**Intel<sup>®</sup> Server Board S5000PAL**  
**Intel<sup>®</sup> Server Board S5000XAL**  
**Intel<sup>®</sup> Server System SR1500AL**  
**Intel<sup>®</sup> Server System SR1550AL**  
**Intel<sup>®</sup> Server System SR2500AL**

*Intel Order Number D65289-017*

**October 2007**

1. The SMBUS block diagram (Figure #16) as provided in Rev 1.1 of the Intel® Server Board S5000PAL/S5000XAL TPS requires changes to accurately reflect production hardware design. 32

## 1. The SMBUS block diagram (Figure #16) as provided in Rev 1.1 of the Intel® Server Board S5000PAL/S5000XAL TPS requires changes to accurately reflect production hardware design.

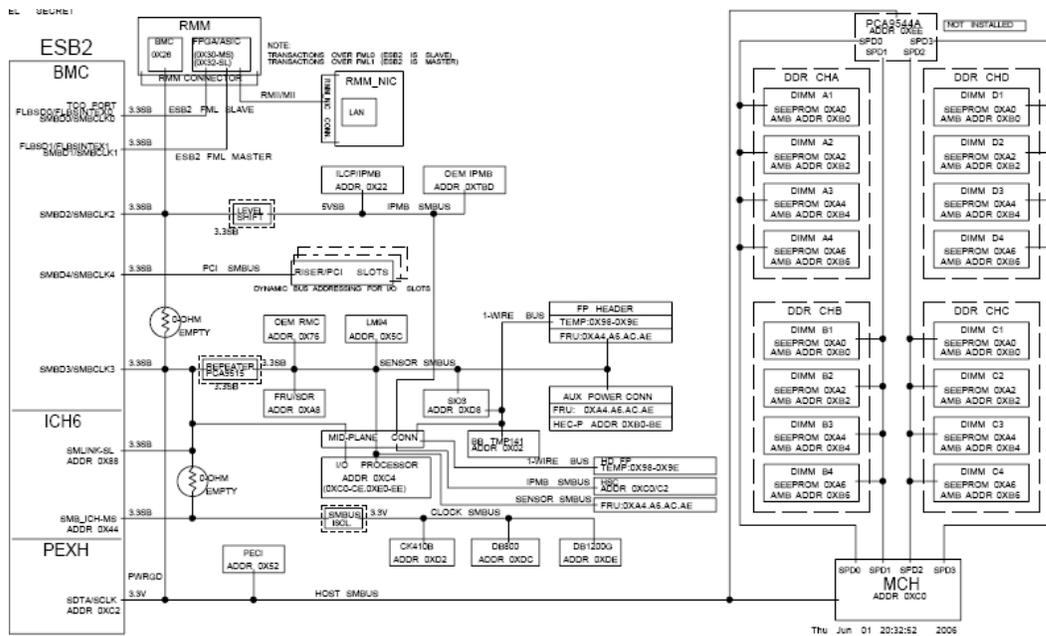
- o Add PECl controller
- o Remove separate HSC connector
- o Correct Midplane -> FP Smbus connections and 1-wire temp sensor
- o Correct Smbus and 1-wire temp sensor connections to FP connector.
- o Correct FBDIMM labeling

The correct diagram is shown below.

**Figure 22. SAS/SAS RAID Mid-plane Board**

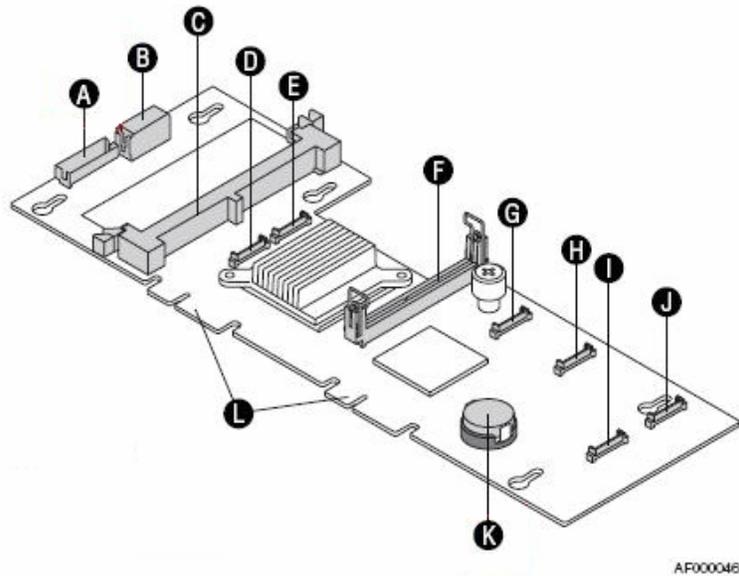
**3. SAS/SAS RAID mid-plane board (Figure #22) as provided in Rev.1.0 of the Intel® Server System SR2500AL TPS should swap the descriptions of items A and K.**

Implication: This is a typo.
